Project	IEEE 802.16 Broadband Wireless Access Working Group < http://ieee802.org/16 >	
Title	Clarify downlink burst profile change management	
Date Submitted	2004-11-01	
Source(s)	Chi-Chen Lee Tzu-Ming Lin Yu-Ren Yang Industrial Technology Research Institute, Computer and Communications Research Labs, Taiwan Bldg. 11, 195 Sec. 4, Chung Hsing Rd. Chutung, HsinChu, Taiwan 310, R.O.C.	Voice: 886-3-5914579 Fax: 886-3-5829733 mailto: jjlee@itri.org.tw mailto: TMLin@itri.org.tw mailto: yryang@itri.org.tw
Re:	IEEE P802.16-REVd/D5	
Abstract	This contribution introduces clarifications for DL burst profile change management procedures.	
Purpose	Adopt into P802.16d/D5 corrigenda	
Notice	This document has been prepared to assist IEEE 802.16. It is offered as a basis for discussion and is not binding on the contributing individual(s) or organization(s). The material in this document is subject to change in form and content after further study. The contributor(s) reserve(s) the right to add, amend or withdraw material contained herein.

Clarify downlink burst profile change management

Figure 79—Transition to a more robust burst profile

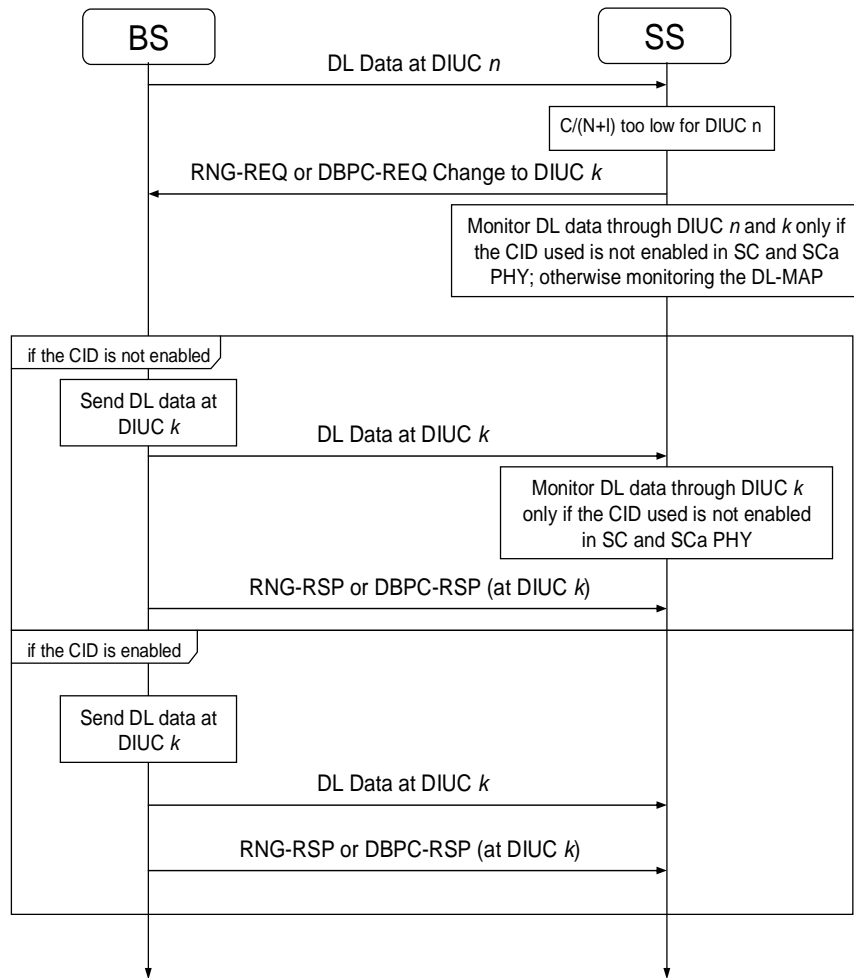
In IEEE P802.16-REVd/D5 “Figure 79 —Transition to a more robust burst profile” and “Figure 80—Transition to a less robust burst profile”, the SS must monitor DL data through two different DIUC while changing the DL burst profile. This scenario is reasonable only if the *CID used* is **not** enabled by burst profile for SC and SCa PHY (see Table 139 and Table 190). In the case of OFDM, OFDMA PHY and in the case of SC, SCa PHY that the *CID used* is enabled by burst profile, the SS’s basic CID is included in each DL-MAP_IE. Thus, the SS can check the DL-MAP for its basic CID and know what DIUC it should use. This design improves the energy efficiency of the SSs that have power consumption constraints. Due to the lack of consistency between this design and the procedures defined in specification, we provide two modified figures to clarify this issue.

[Replace Figure 79 and Figure 80 with the following figures.]

Figure 81a—Wait for response during change of DL burst profile—SS

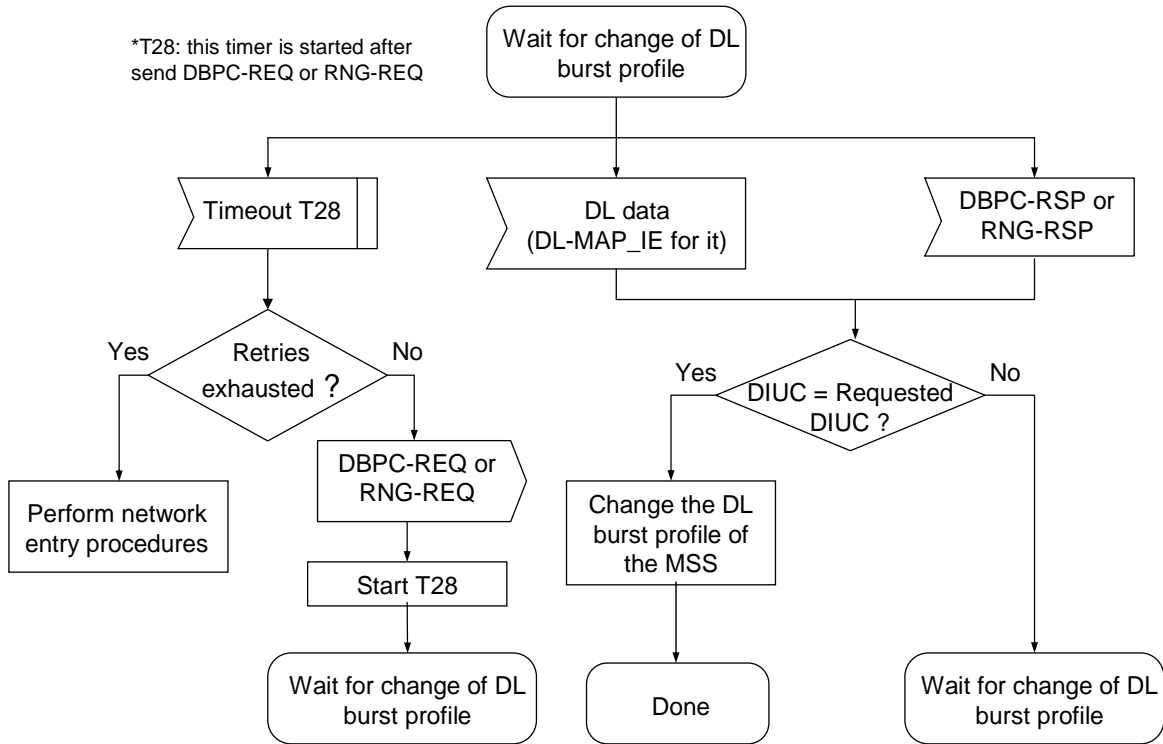
We notice that DL burst profile management does not mention how the SS deals with the lost of the change request. However, the change request may be lost due to the contention or harsh mobile environment. Therefore, the additional flow chart (see Figure 81a) is proposed to make the change of DL burst profile more robust. The new timer T28 is designed for handling the lost of the DBPC-REQ or RNG-REQ during the change of DL burst profile. Note that the BS should send DL data at new DIUC or send the DBPC-RSP or RNG-RSP to the MSS before T28 times out.

[Insert new figure before “Figure 81 – Burst profile threshold usage” with the following figure.]
